To: Adam Grady, Hanover Design Services
From: Pat O’Mahony, Associate Planner; 910-341-0189
CC: File;
Date: 2/15/2021
Re: Legacy Pointe Minor Sub. TRC Rev. 1

Project Name: **LEGACY POINTE MINOR SUBDIVISION**

Engineering has reviewed the plans for the Legacy Pointe Minor Subdivision project submitted January 8, 2021 for TRC review and have the following comments:

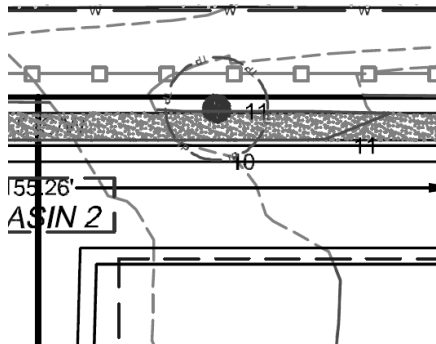
- Are any existing structures proposed to be removed? Please label as such.
- Clarify tree removal. Tree protection is shown, but it looks like the tree will have to be removed. See below:
